ACTION TRANSMITTAL No. 2016-38

DATE: June 7, 2016
TO: TAC Funding and Programming Committee
PREPARED BY: Joe Barbeau, Senior Planner (651-602-1705)
SUBJECT: Scope Change Request for City of Brooklyn Center Evergreen School Area Trail and Sidewalk System
REQUESTED ACTION: The City of Brooklyn Center requests a scope change to its Evergreen School Area Trail and Sidewalk System TAP-funded intersection signal project (SP # 109-591-001) to remove installation of curb-and-gutter from the project.
POSSIBLE ACTIONS: The Committee can recommend approval or denial of the request. If it recommends approval, the Committee can recommend full federal funding or a reduction in federal funds.

RE: Scope Change Request
Evergreen School Area Trail and Sidewalk System
SP 109-591-001
City of Brooklyn Center

**Evergreen School Area
Trail and Sidewalk System**
Proposed Trail/Sidewalk Locations

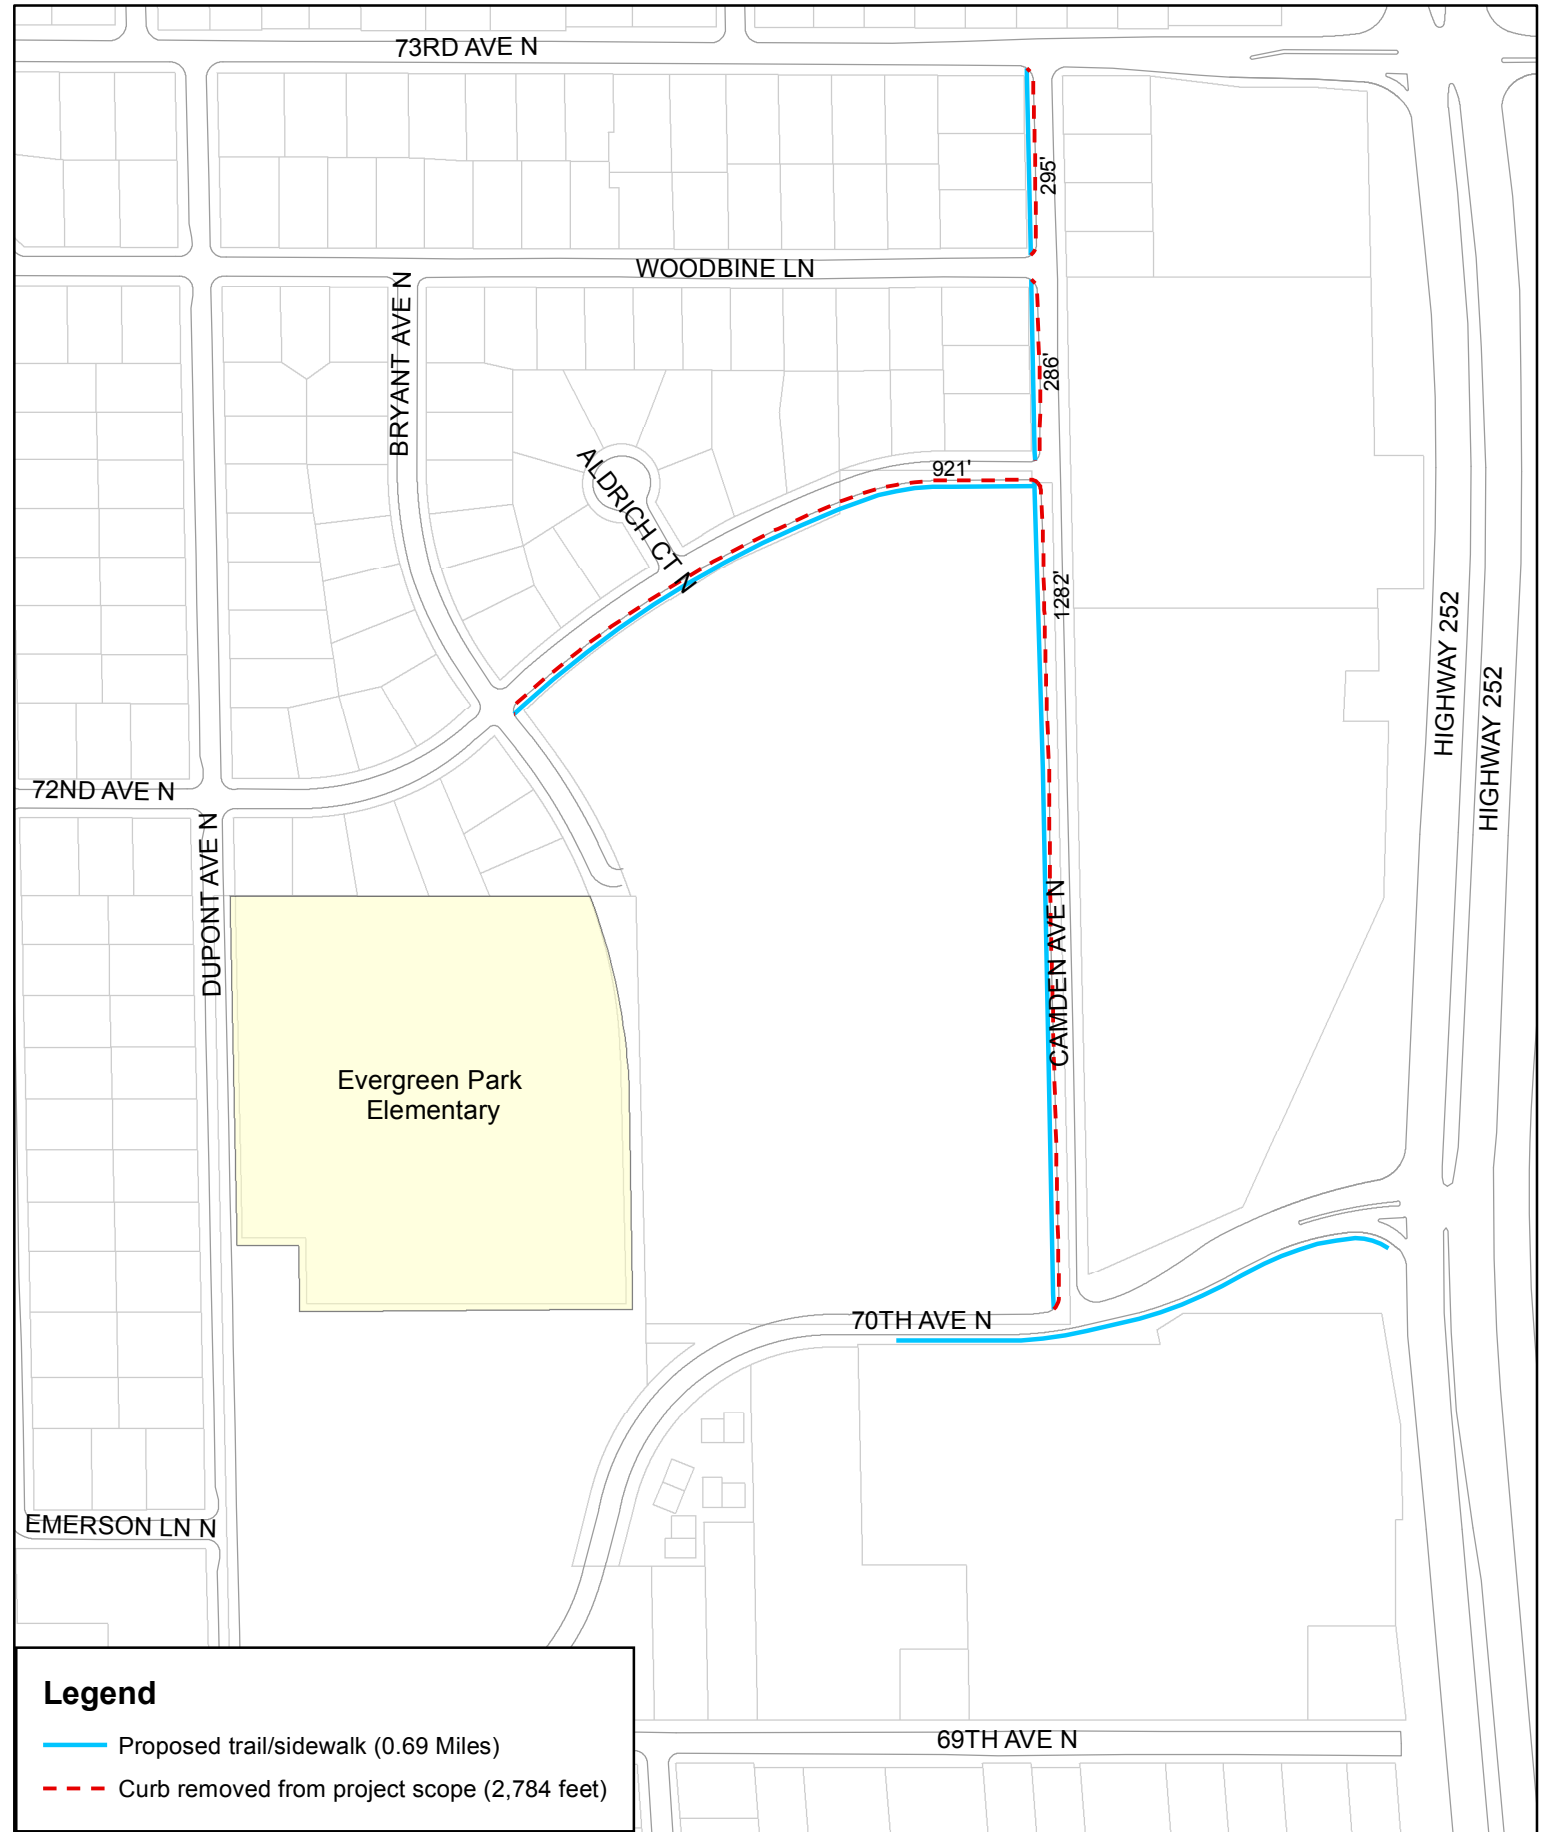
The City is requesting that curb-and-gutter, which is to be included along Camden Avenue North and 72nd Avenue North (2,784 cumulative feet) be eliminated from the project.

Specifically, the scope change is the removal of the curb and gutter from the project. The City believes that the curb and gutter installation would be more appropriately constructed with the concurrent and adjacent street and utility improvement project in this area. The cost of the curb and gutter was estimated at \$27,500 in 2014 dollars.
